ADDENDUM NO. 1

DATE: April 13, 2020
FROM: City of Grand Junction Purchasing Division
TO: All Offerors
RE: 2020 Horizon Place Street Reconstruction IFB-4784-20-DH

2 DUMPSTER ENCLOSURE DETAIL
1/4" = 1'-0"

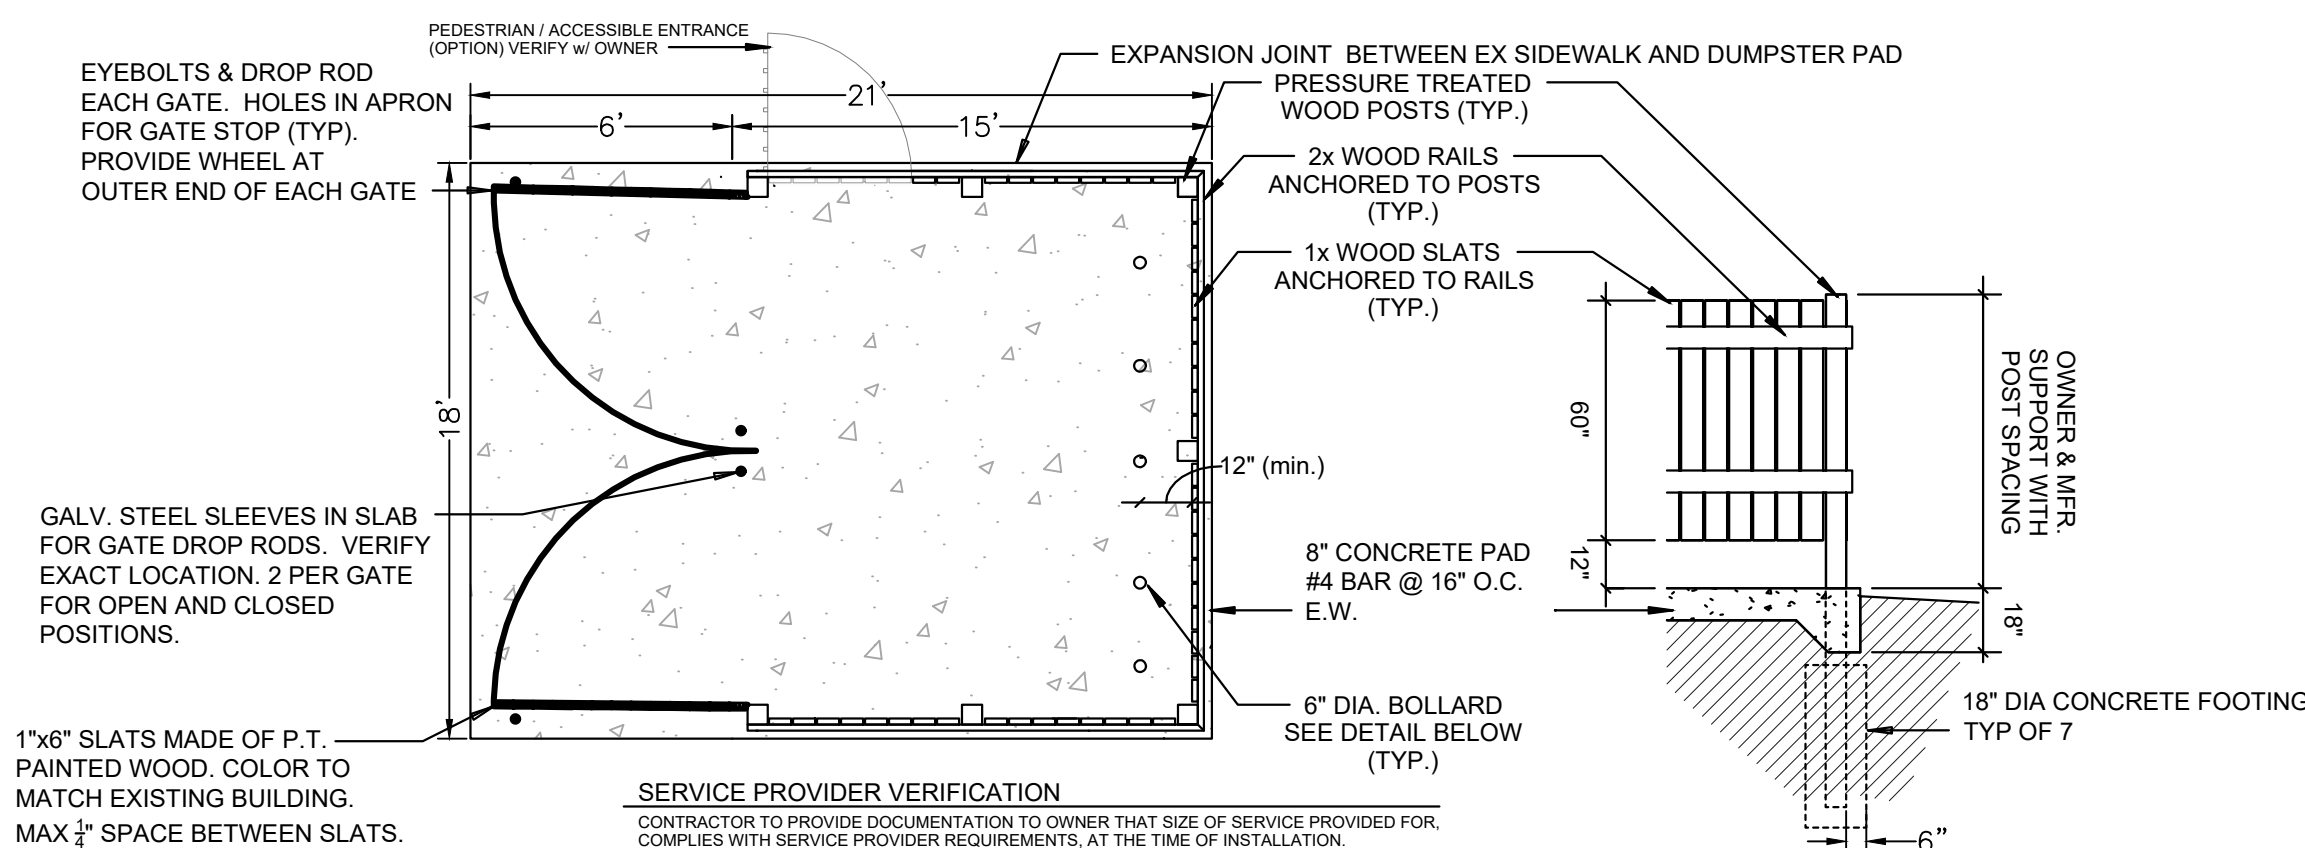
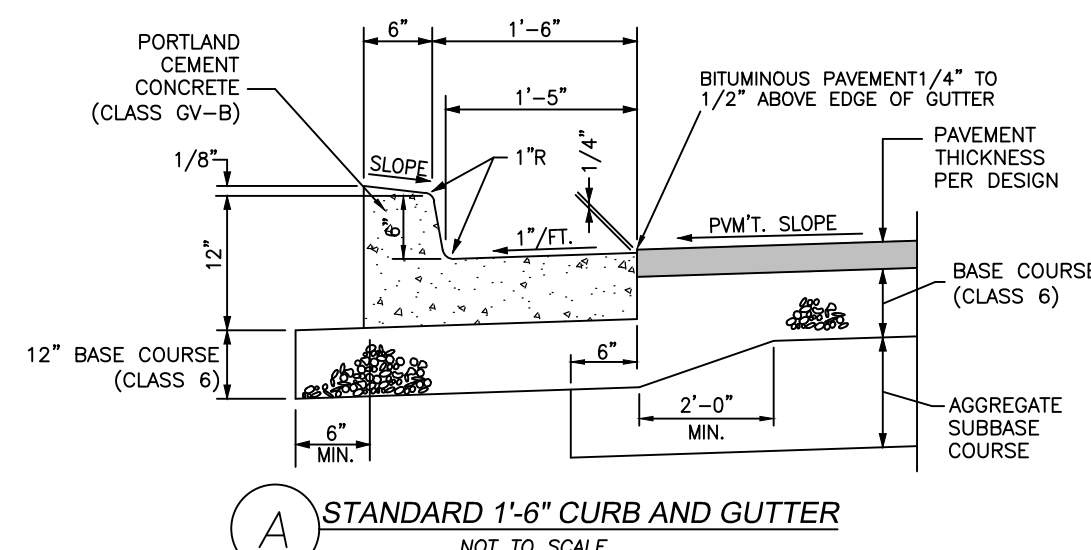
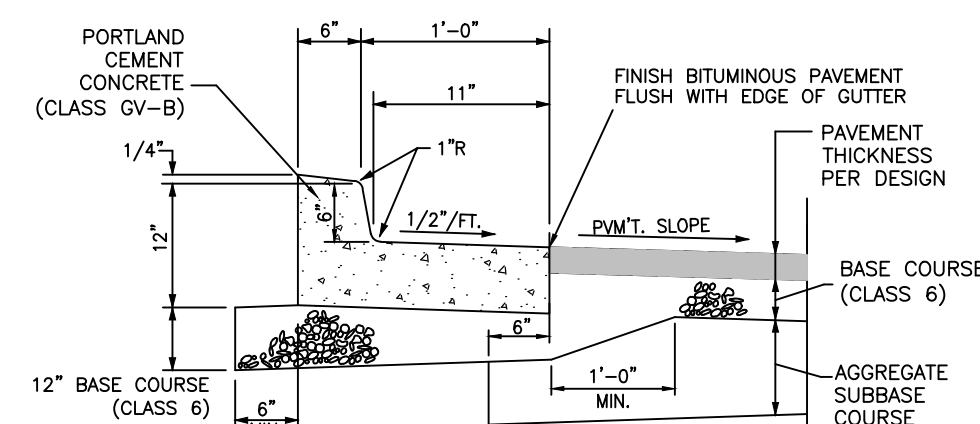
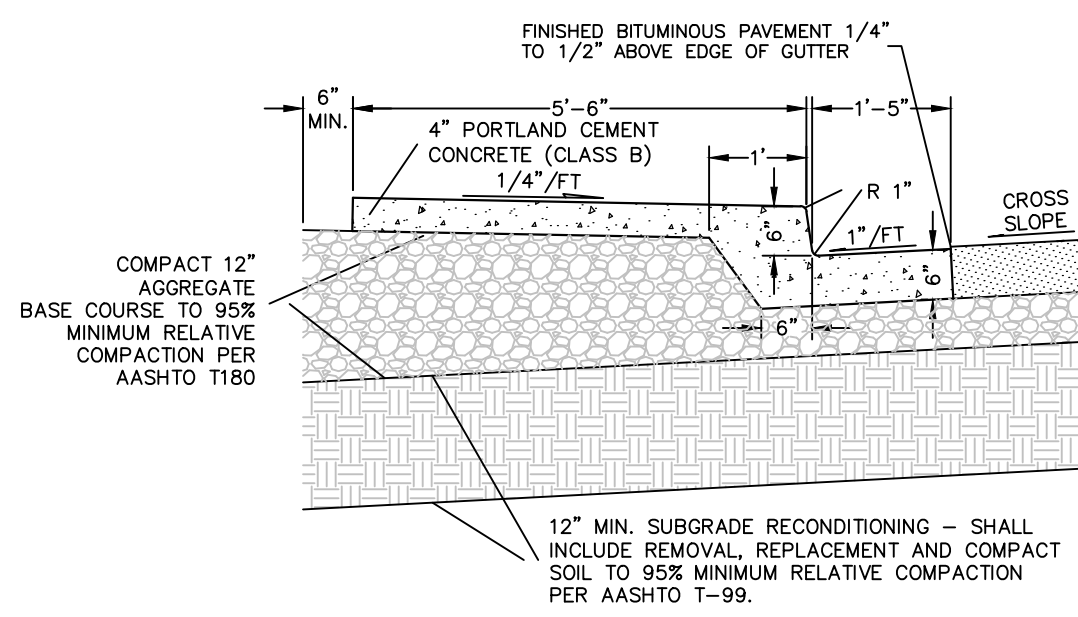
1. Q. Does the new enclosure include walls or a thickened edge for the slab?

5. Q. Per Dumpster Enclosure Detail 2 on sheet C-2 of the bid plan set there is an 18" thickened edge on the dumpster enclosure slab. Is the thickened edge only at the locations of each fence/hinge post, along parameter of proposed fence, or along whole parameter of the dumpster enclosure slab (including apron)?

A. Yes. Please see the details on page C-2 of the Plan Set. Also, see the updated bid schedule.

A. The thickened edge should be constructed at the edges of the slab where the posts are to be set.

3. Q. Per Paving Construction General Note 7 on sheet C-2 of the issues bid plan set, the "Rigid Pavement" is to be constructed of, "6-Inch Portland Cement Concrete w/ #4 bars @ 16-Inch OC EW". The proposed driveway access to the West is to be constructed of 8-Inch non-reinforced concrete. Extending to the South from this proposed driveway access, called out on sheet C-4 is approx. "34 SY of new 8-Inch concrete pavement". In regards to this proposed concrete pavement section was the intent of the Design team to follow the depth and reinforcement parameters described in the above-mentioned General Note 7?

A. The concrete depth in the note has been changed to 8". The reinforcement parameters have been updated as well. Please see the updated plan set.
